**City of Biddeford
Historic Preservation Commission**

RE: **Item 4.1: 2025.37 HPC Review** Archetype Architects to revise the design of a previously approved project at 6 and 14 Main Street, Tax Map 71, Lot 10/1 and Tax Map 71 Lot 10/4, respectively, in the MSRD-3 Zone.

Modification Request

Project:
BUILDINGS 19 & 20
PEPPERELL, BIDDEFORD, ME

1 MAIN STREET ENTRY - EXISTING AND DEMO
1/4" = 1'-0"

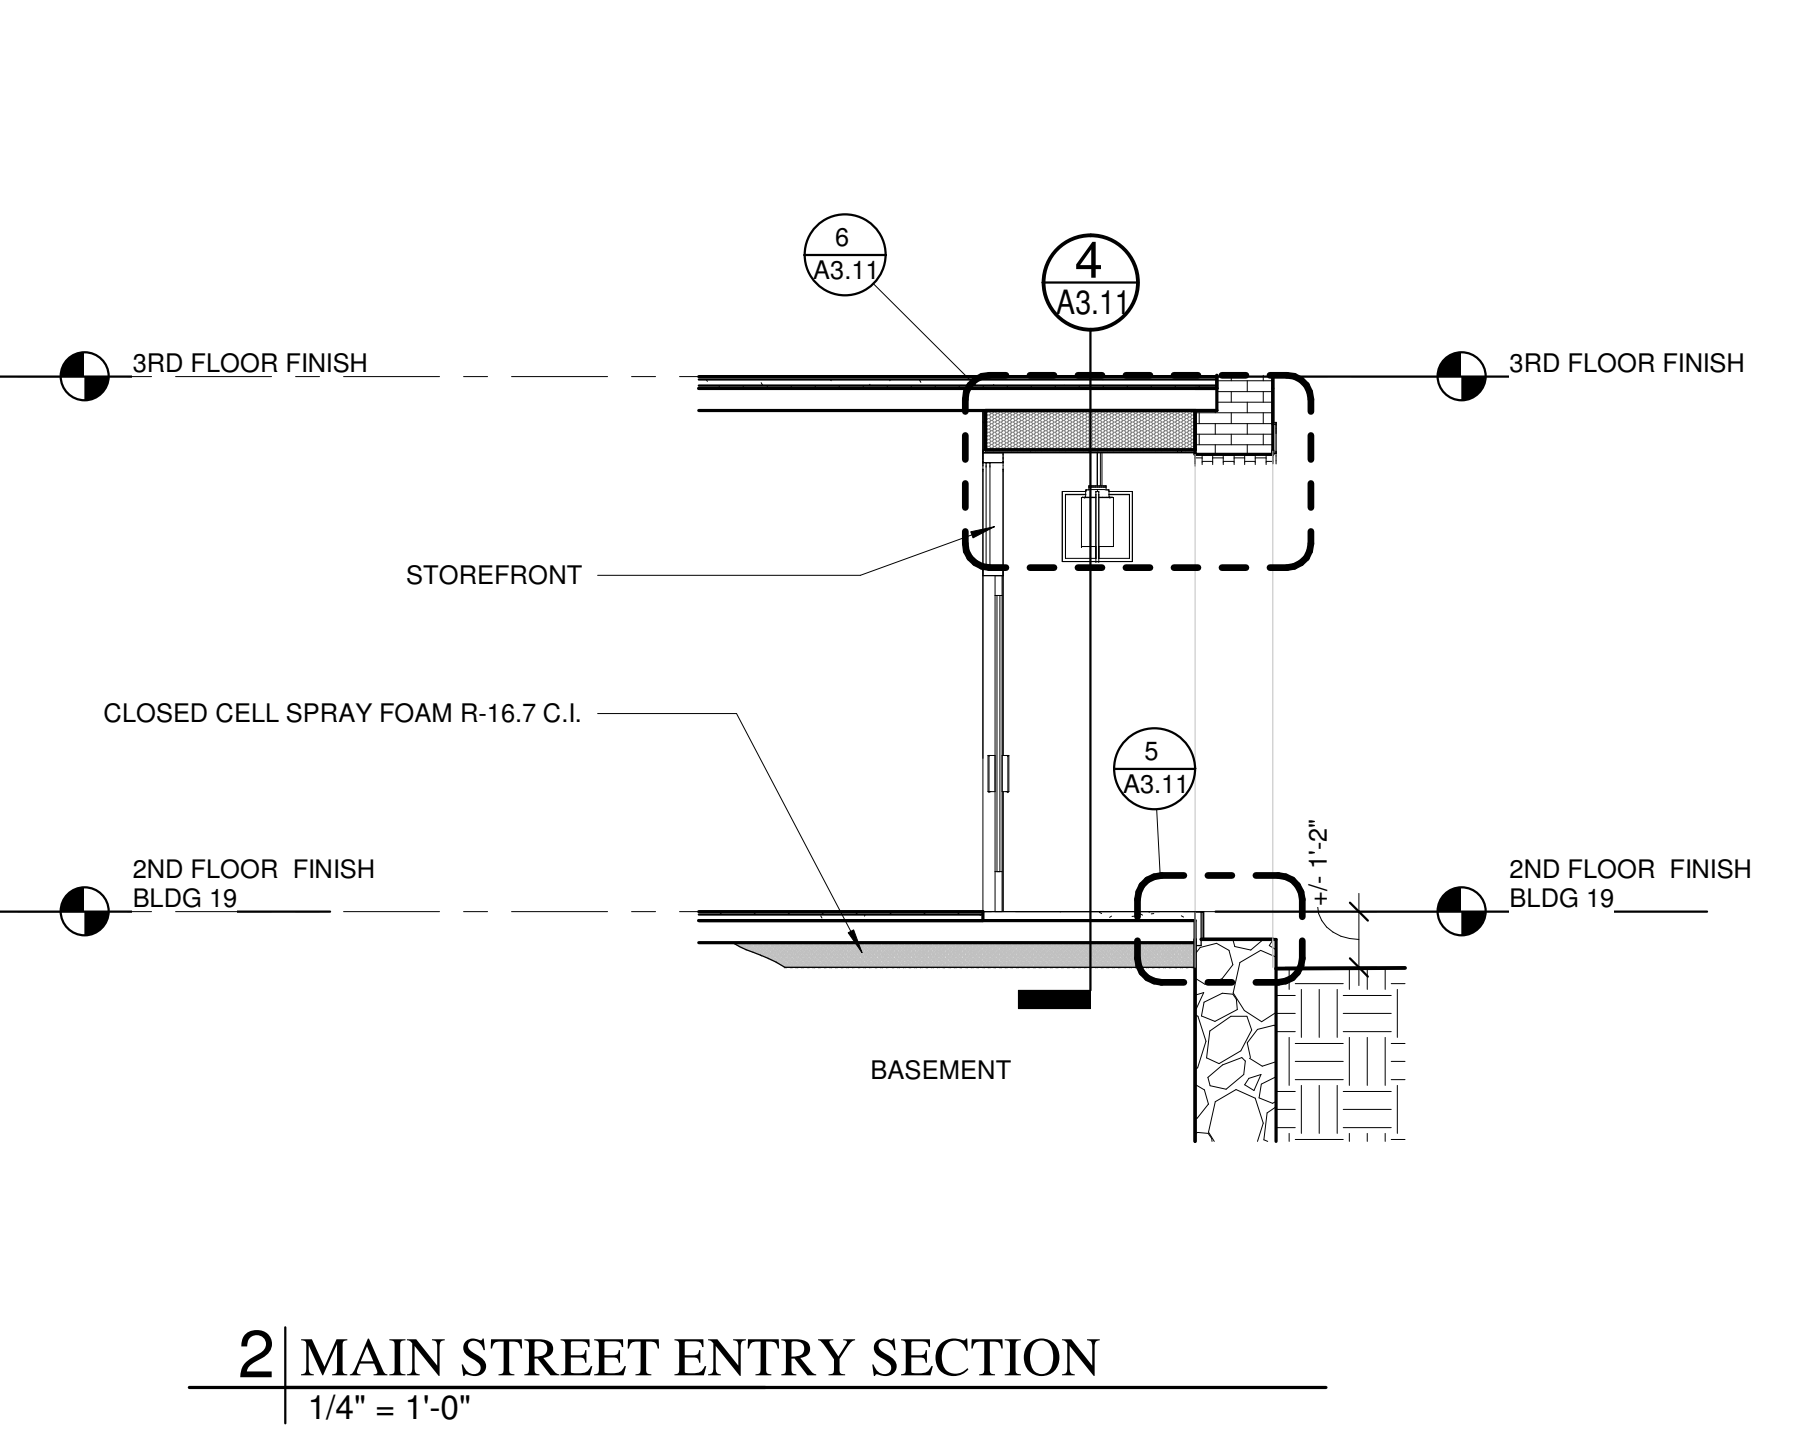
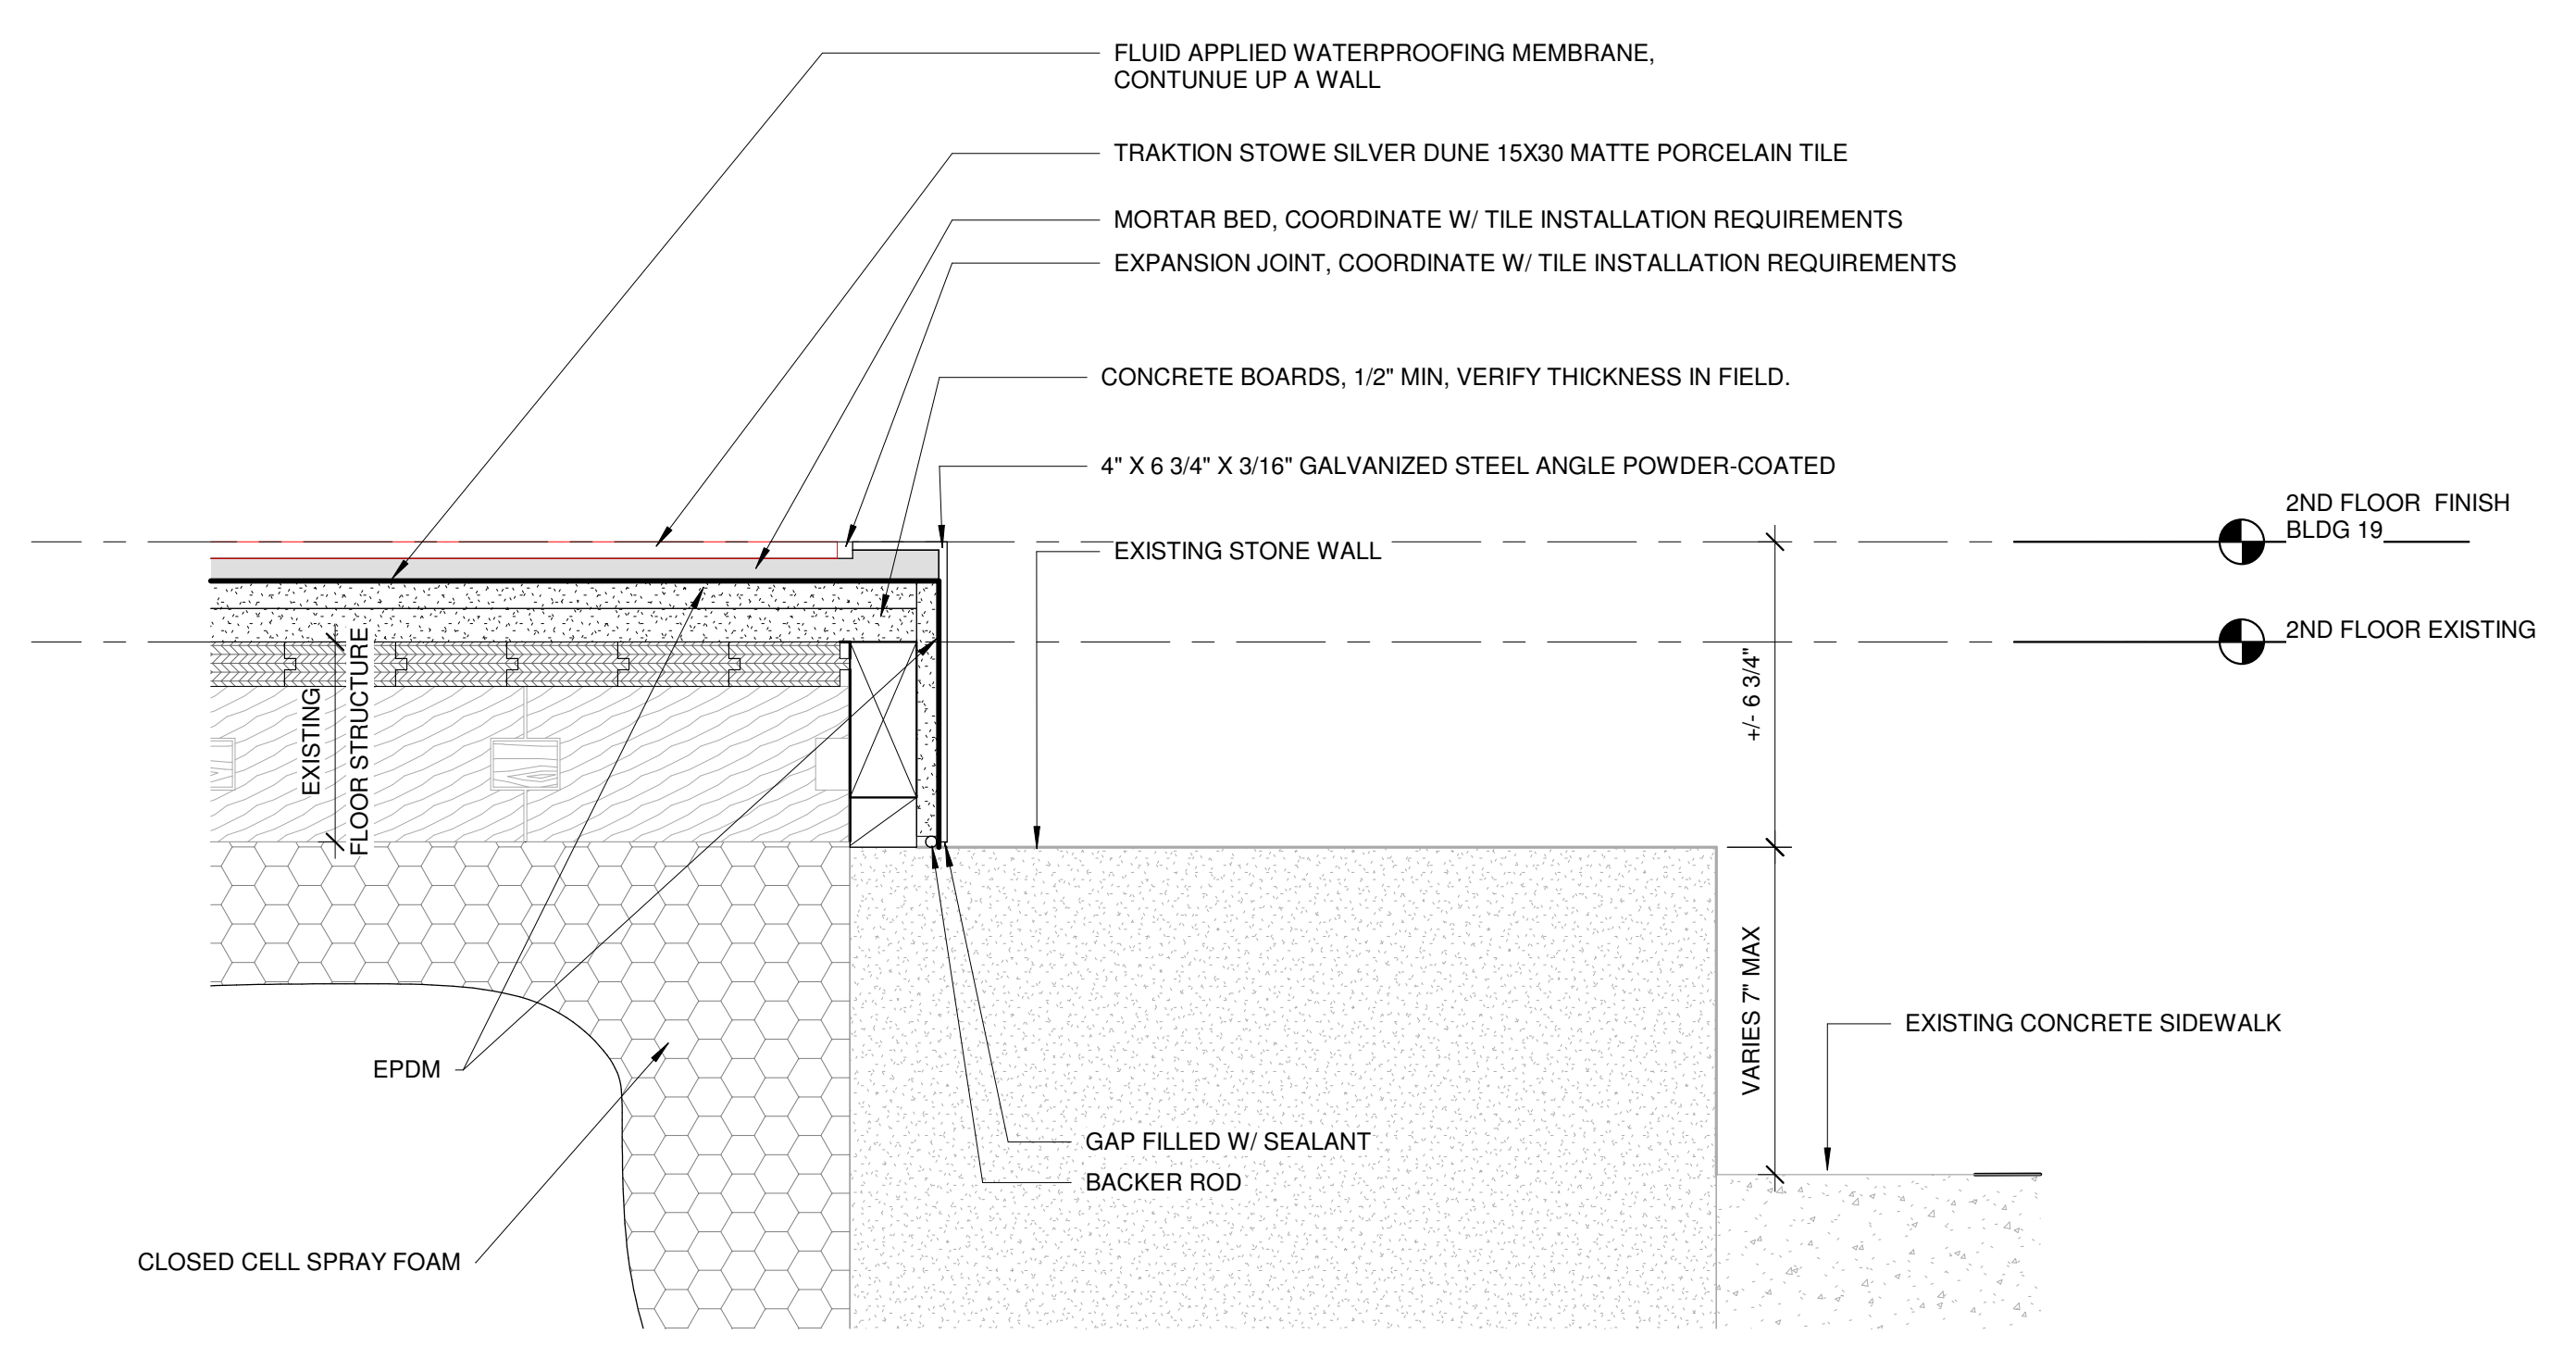
We propose adding a new entry of Main Street located in building 19 on the 2nd floor between column lines 20 and 21. The entry door will be recessed and will swing outward into a small entryway. There will be two risers and handrails. An exterior pendant light fixture will be installed in the recessed entryway. See Dwg A3.11 dated 11/14/2025.

Building 20 – WEST ELEVATION

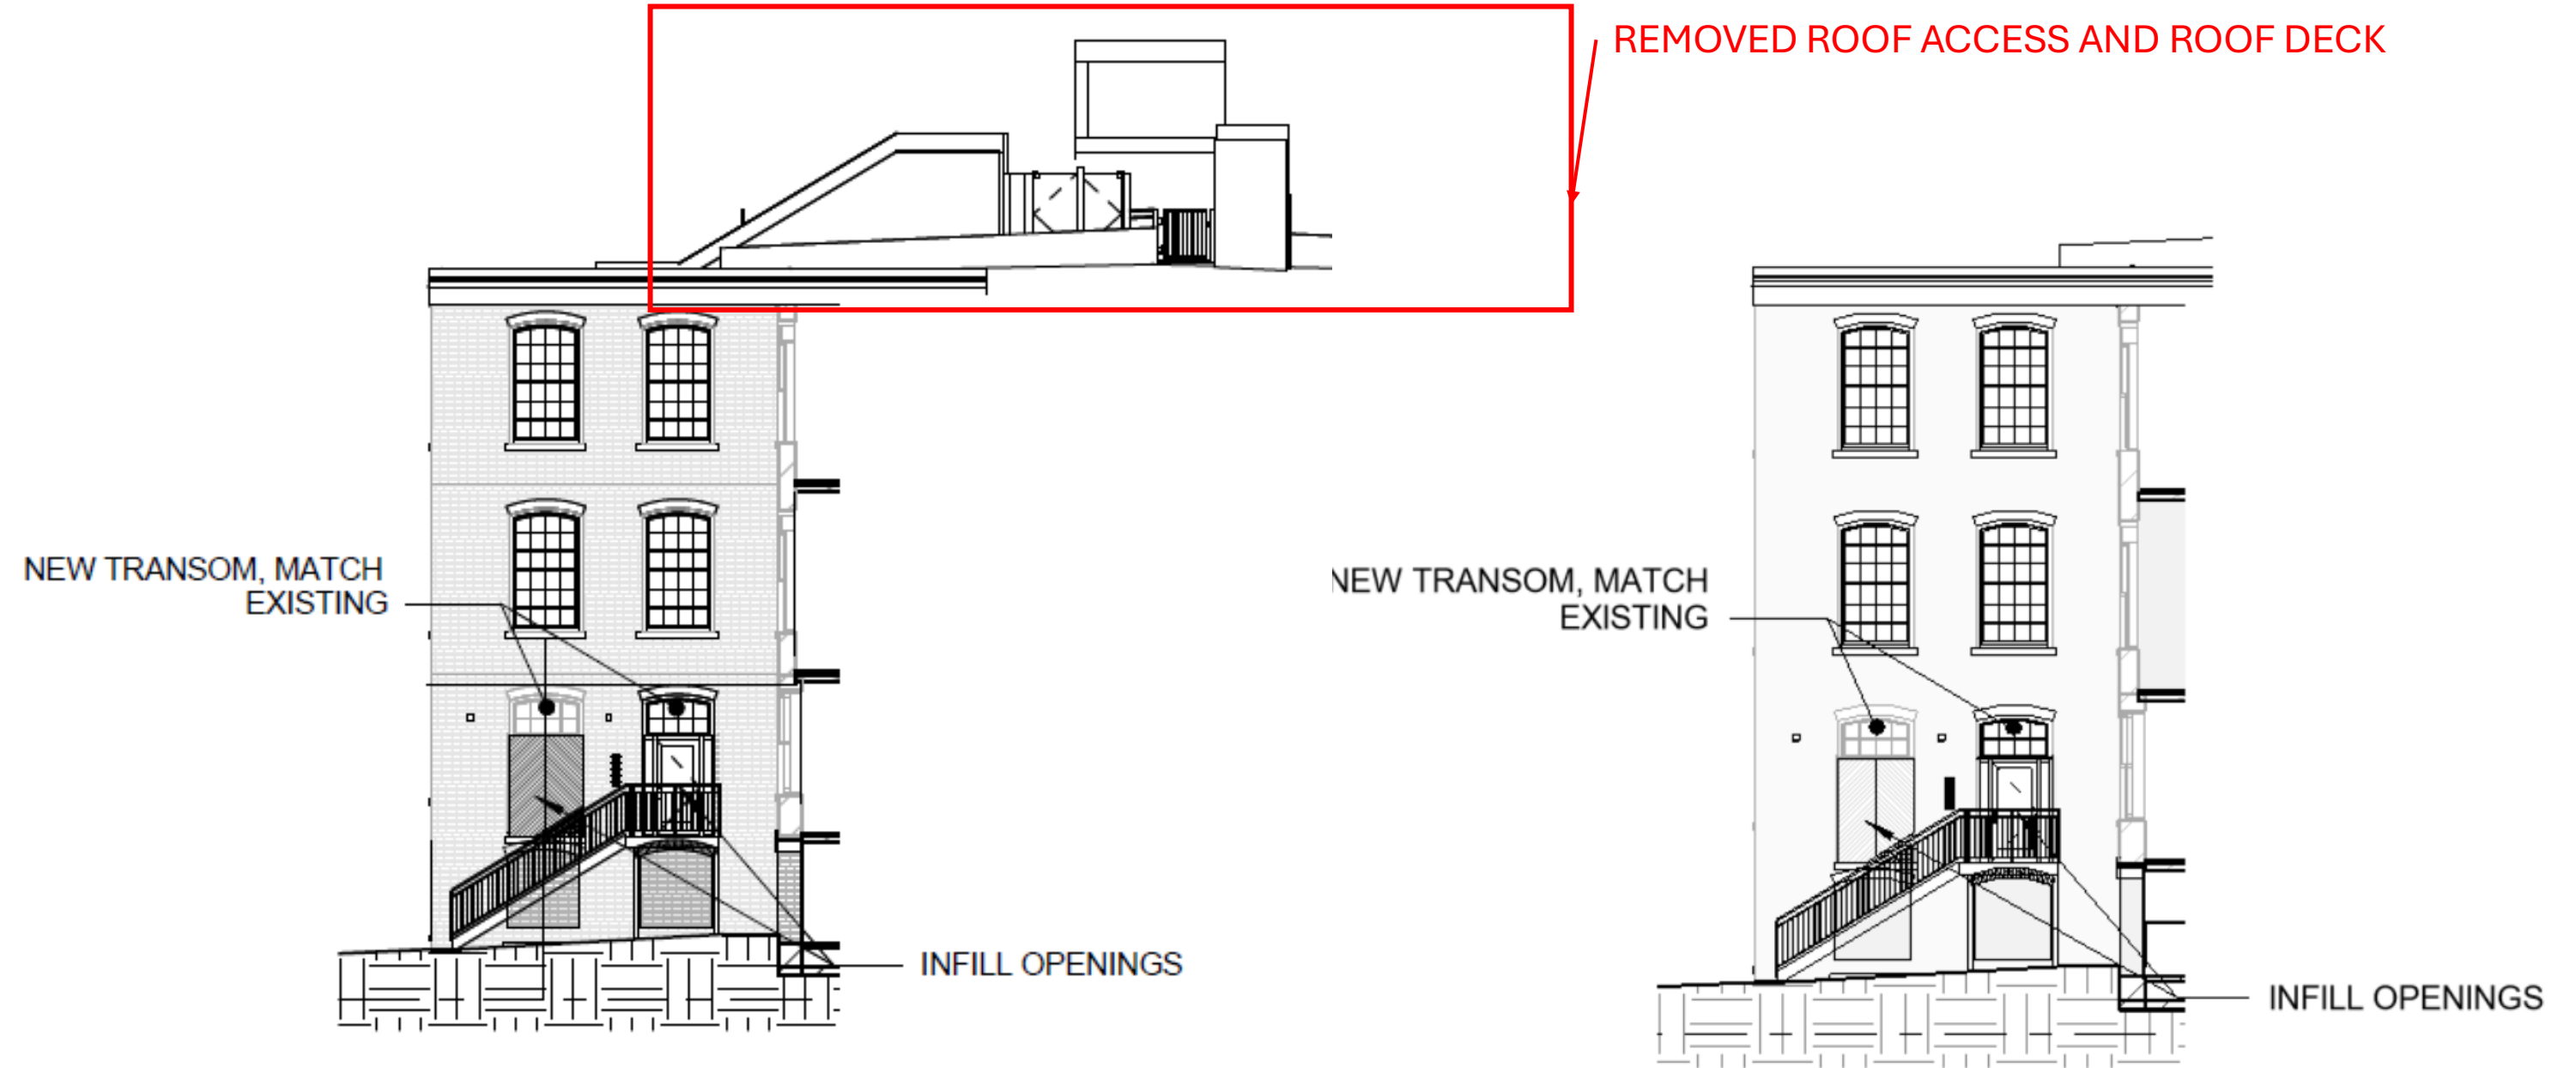
APPROVED BY PLANNING
10/9/2024

PROPOSED REVISION
11/14/2025

Building 20 – EAST ELEVATION

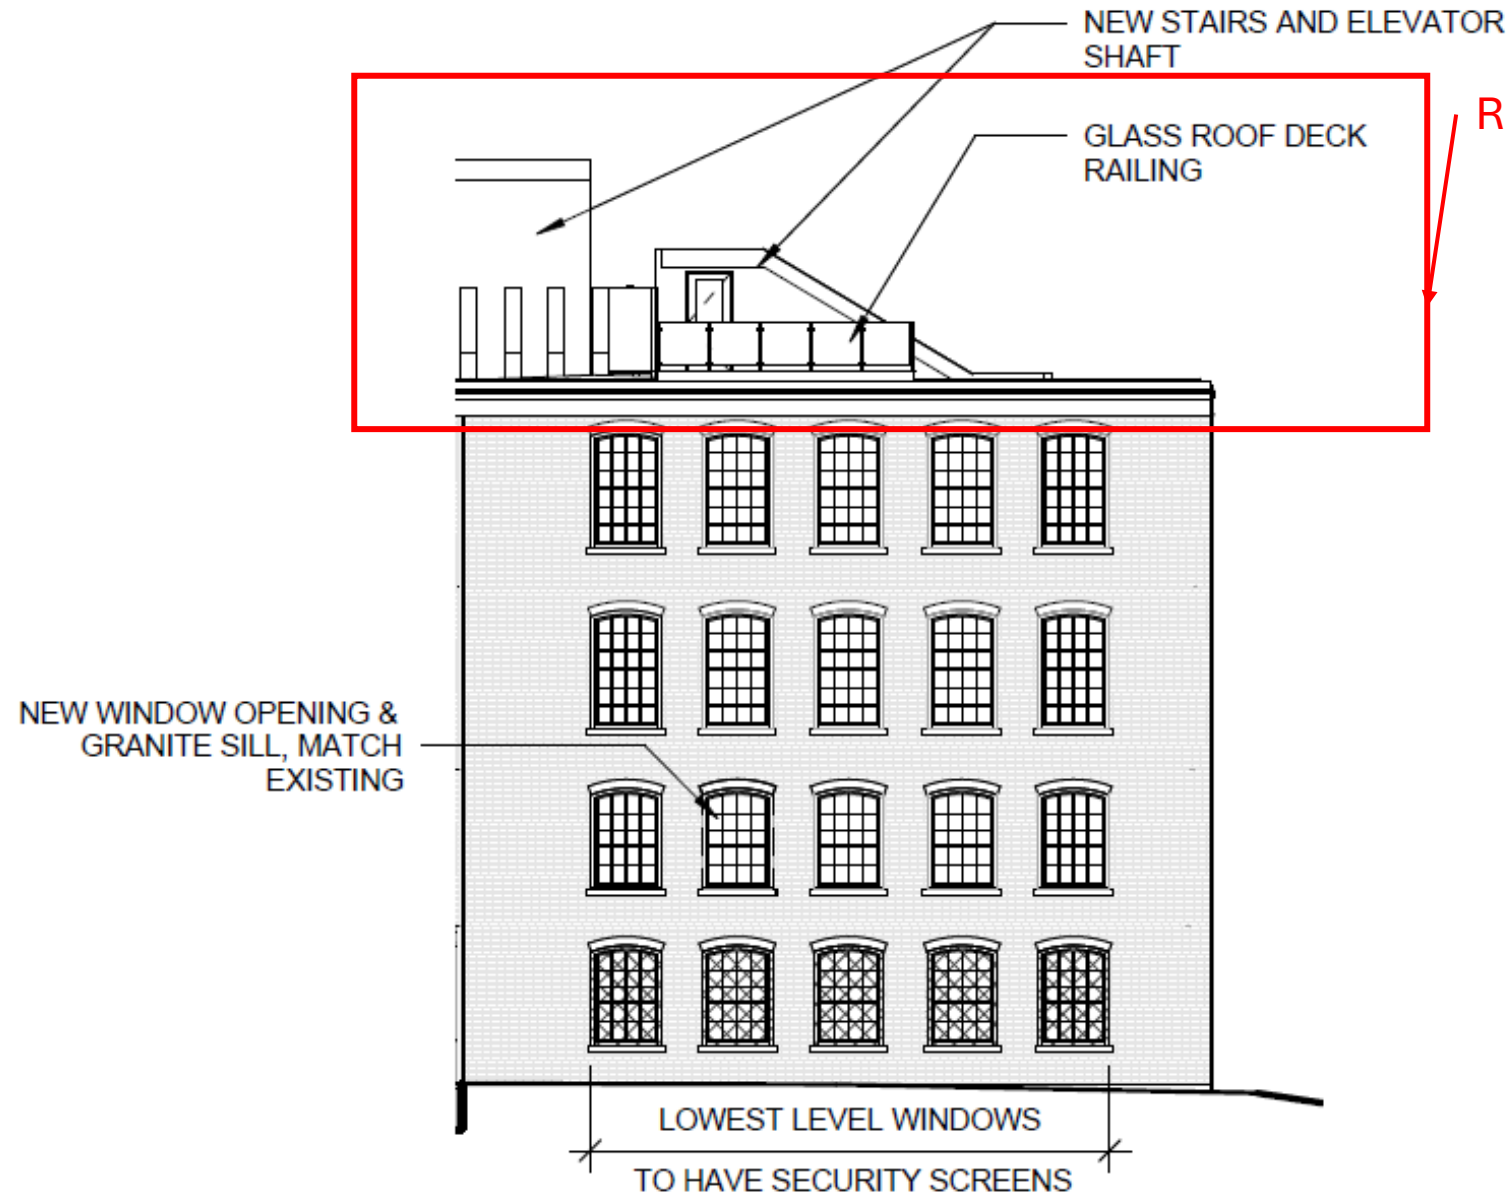
REMOVED ROOF ACCESS AND ROOF DECK
